# 01-079 - AC Stops Blowing Cold Intermittently

01-079

HVAC Intermittently Stops Blowing Cold Air

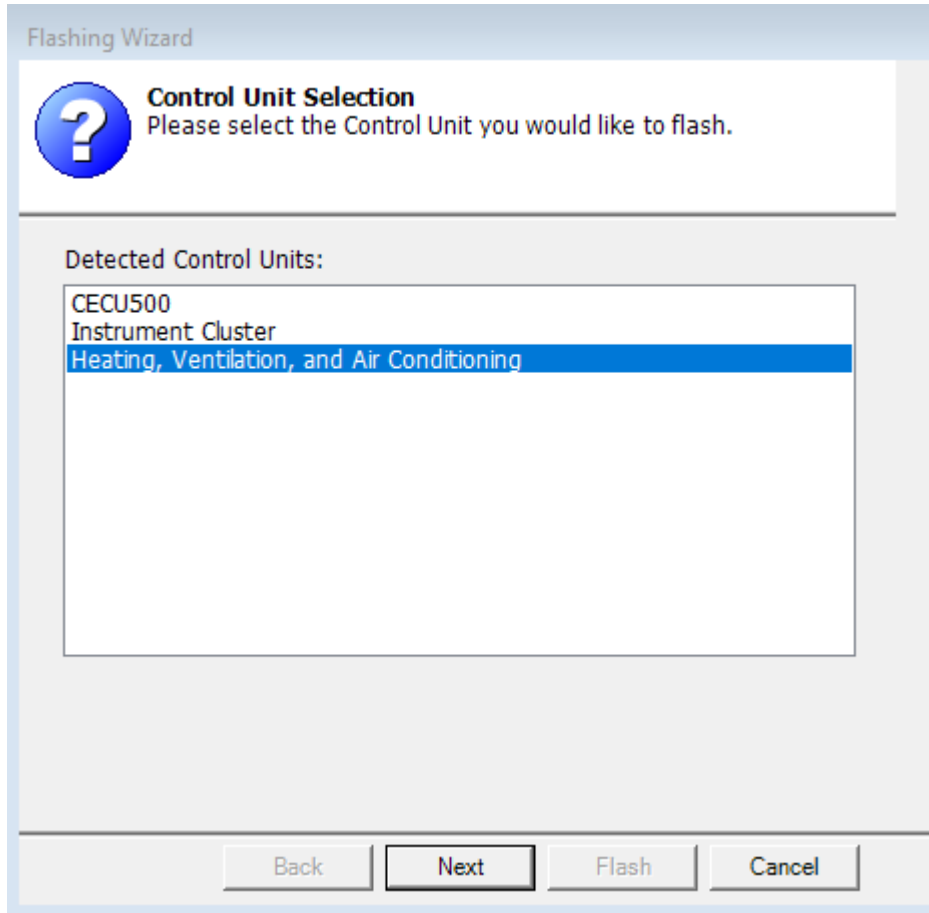
If the software update and power disconnect/re-connect steps do not resolve the issues, a new HVAC control head can be ordered.

Quantity	Part Number	Description
1*	F21-1048-*****	Control – Cab HVAC
1*	Q21-6021-****	Control – Cab HVAC

\*Order if software update and power disconnect/reconnect do not resolve issues. Choose variation needed based on unit installed in vehicle.
